## ILLINOIS EPA RCRA CORRECTIVE ACTION CERTIFICATION

Response to IEPA comments provided in their 5/5/23 SEE System approval/comment letter.

**Former Public Works Yard Steam Enhanced Extraction – Response to 5/5/2023 IEPA Letter  
Roxana, Illinois  
1191150002 – Madison County  
Equilon Enterprises LLC d/b/a Shell Oil Products US  
Log No. B-43R-CA-109**

Figure 1: Example of a mass recovery curve not requiring statistical analysis

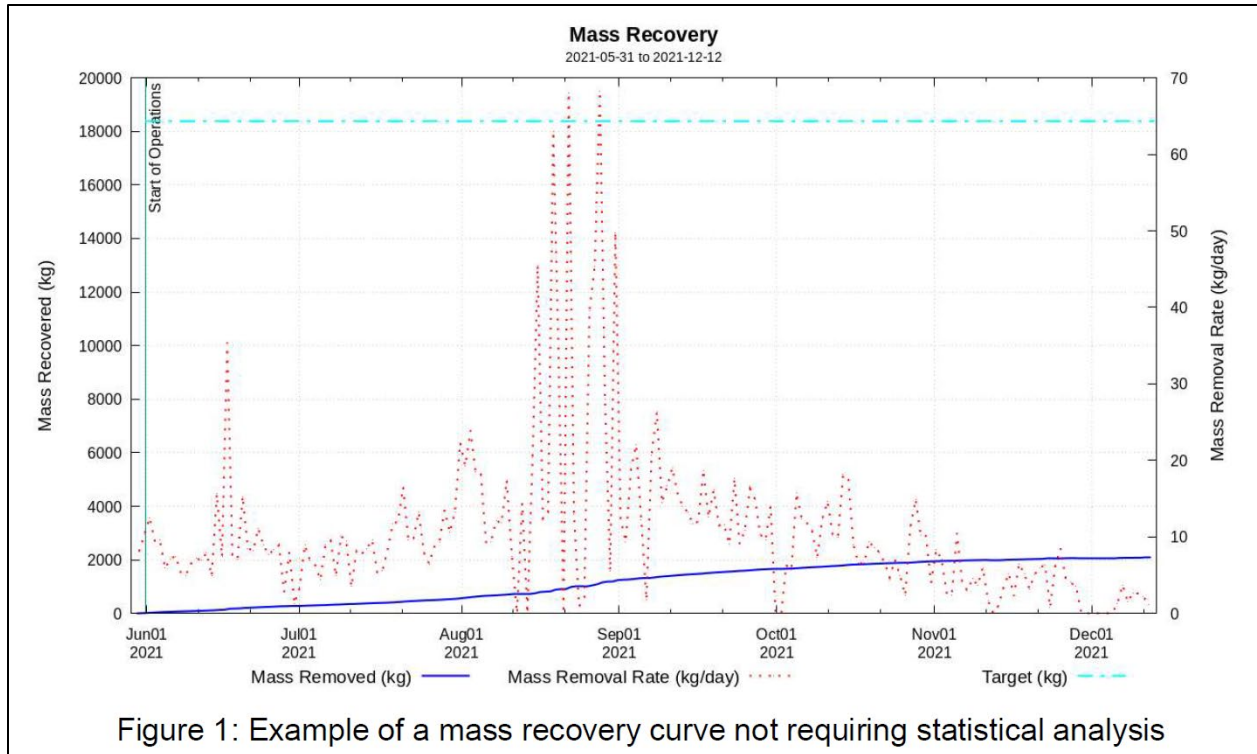
*The attachment describing the Mann-Kendall analysis suggests a minimum five years of monthly data for a monotonic trend analysis. Considering that this SEE project is estimated only for about a six month period, SOPUS must provide a better understanding and information to the Agency on how the utilized Mann-Kendall analysis would be accurate enough to dictate shutdown of SEE.*

In the first example project, shown in Figure 1, the daily mass recovery rate at peak removal is approximately 68 kg/day and the final 14 days of operation show consistent mass recovery of less than 6.8 kg/day. From this analysis, it was determined that asymptotic conditions had been achieved and additional in-situ remediation would provide diminishing returns. The in-situ thermal remediation system was shut down.

FIG. NO.  
7 (rev.1)

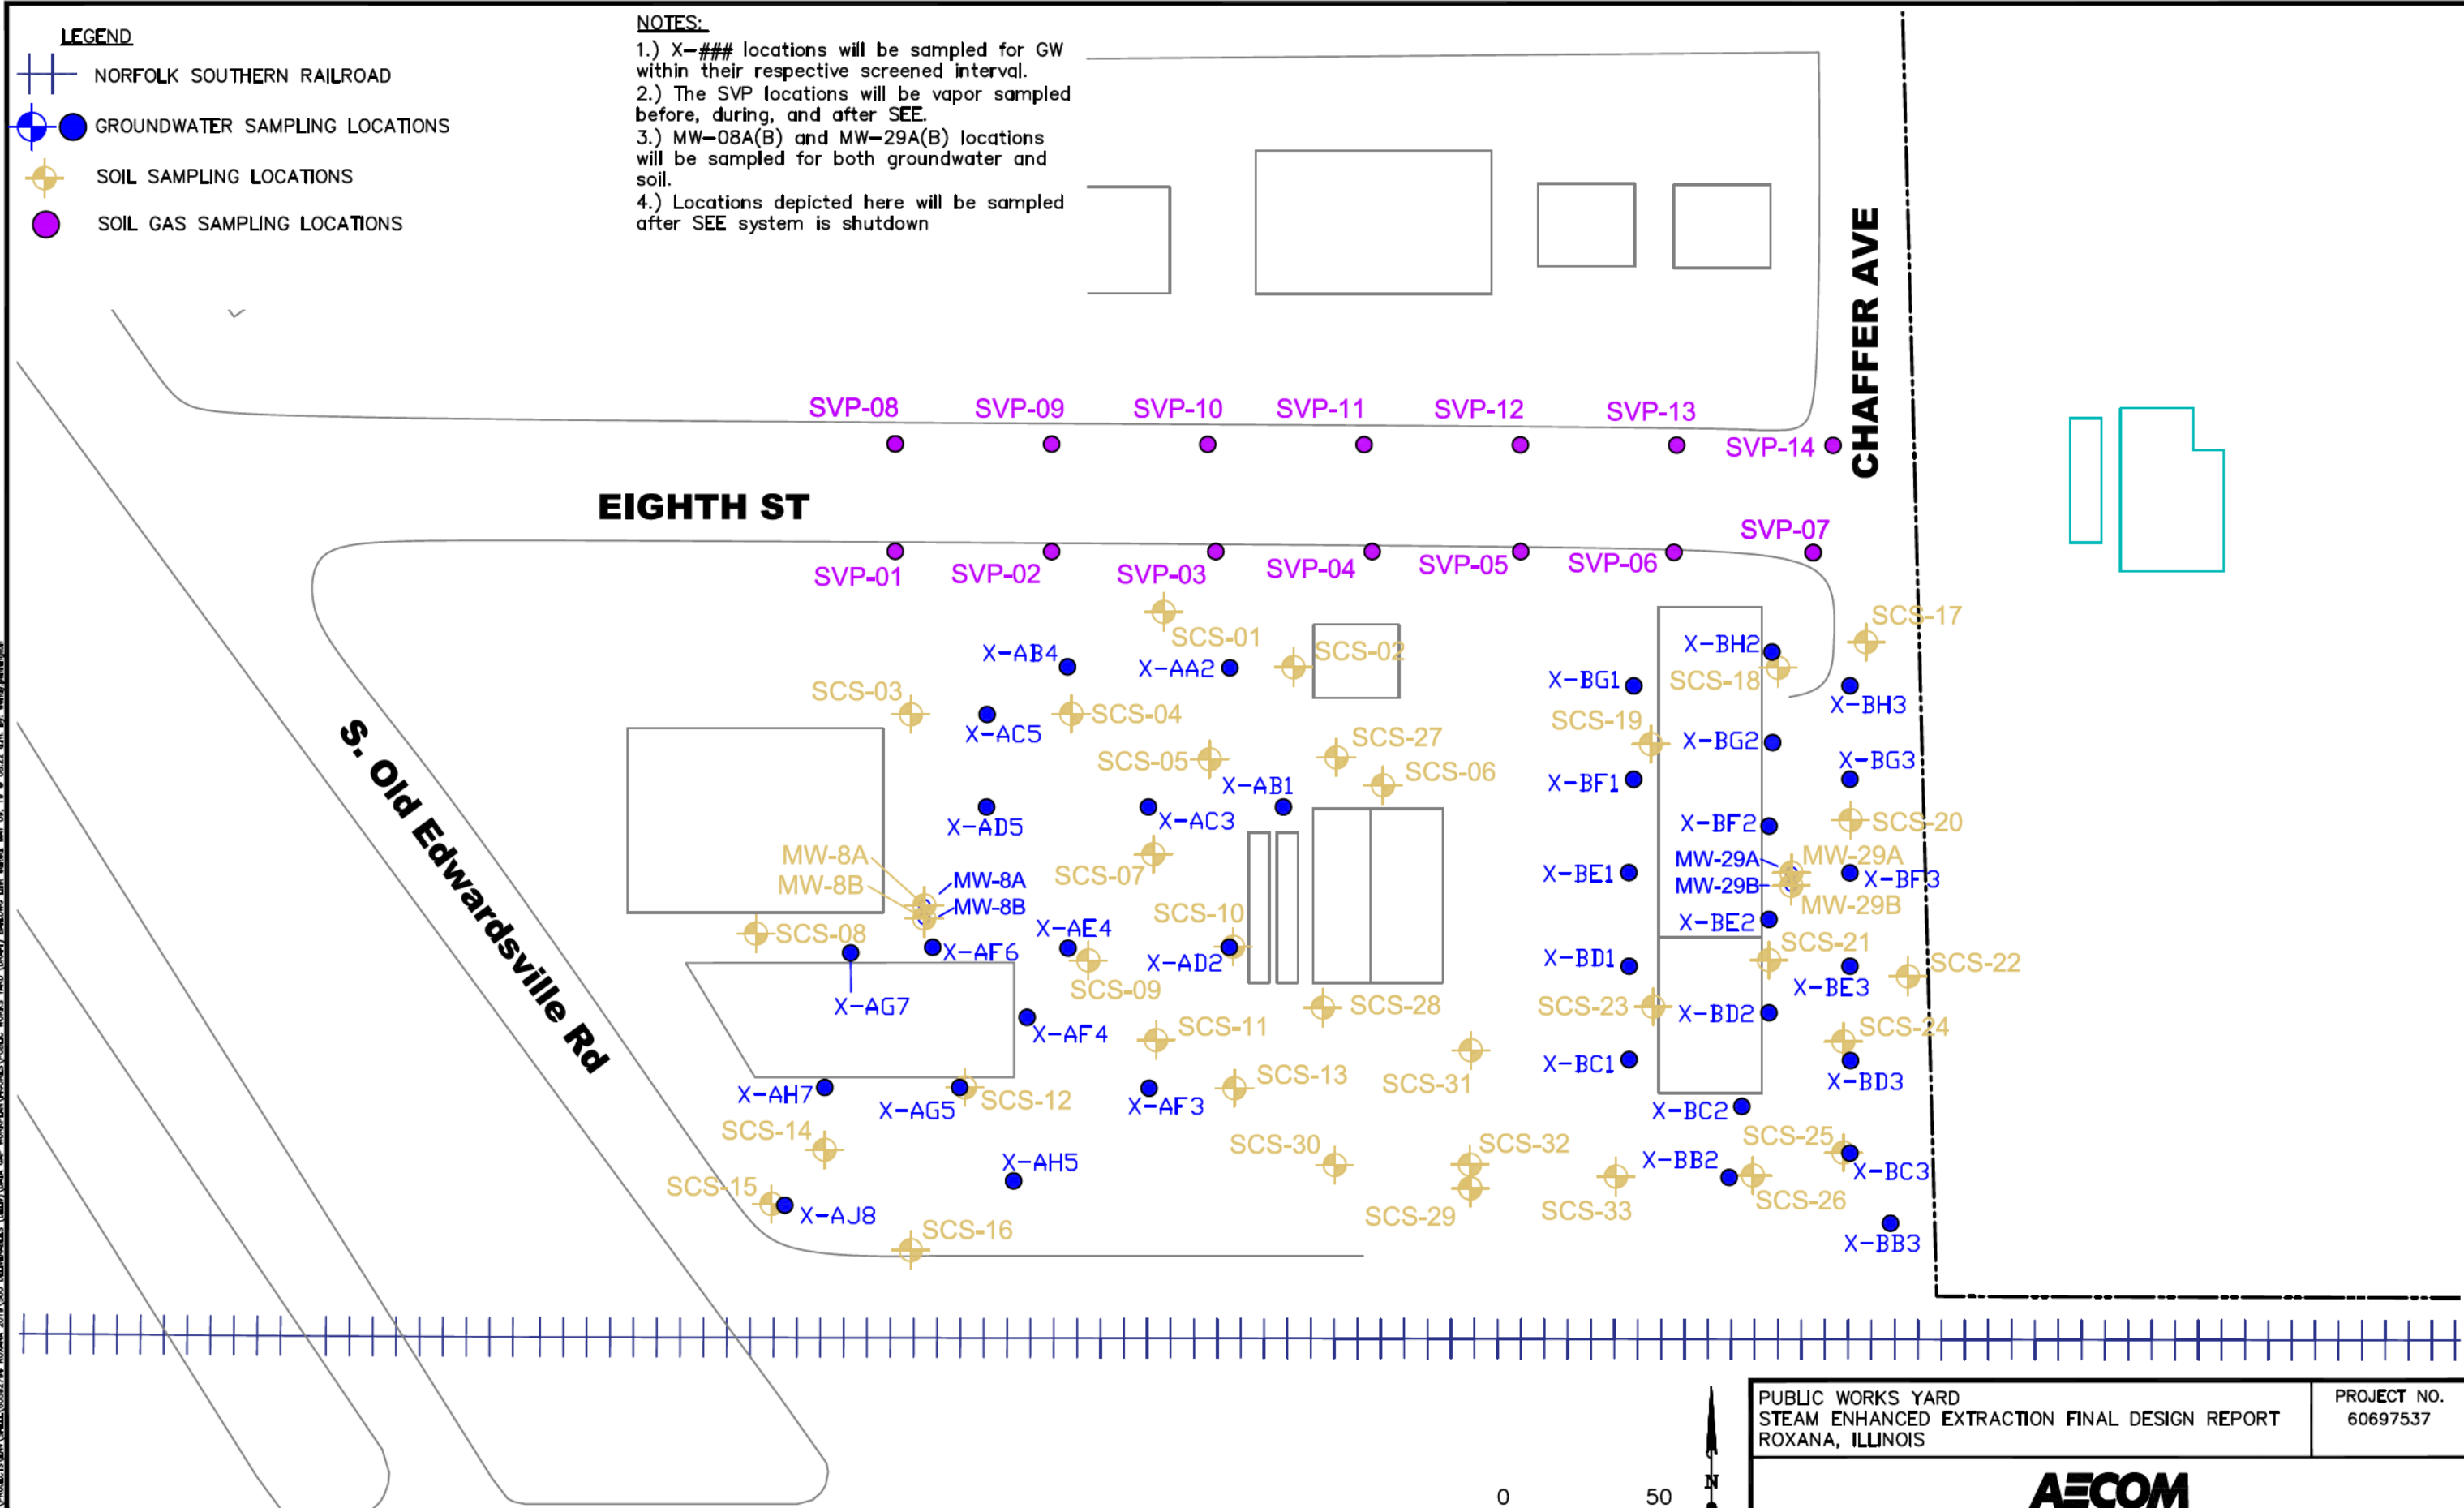
*SOPUS must increase the number of post-SEE sampling locations to match the pre-SEE sampling. The post-SEE sampling locations have decreased to twelve (12) locations compared to the thirty-one (31) pre-SEE sampling locations. Collecting samples from a similar number of sampling locations both prior to and after SEE would provide more accurate information on the effectiveness of the SEE system as well as a better understanding of the extent of remaining contamination in the PWY.*

The condition is acknowledged. Post-SEE sampling locations within the thermal treatment boundaries will match the Pre-SEE sampling locations as closely as is possible with field conditions. Soil and groundwater samples at SVP borings will not be collected after SEE operation because those locations are outside thermal treatment boundaries. Post-SEE soil vapor samples will be collected at SVPs per the Steam

Extraction Vapor Monitoring Plan (FDRCWP **Section 5.2**). Enclosed Figure 7 (rev. 1) illustrates the new Post-SEE sampling locations.
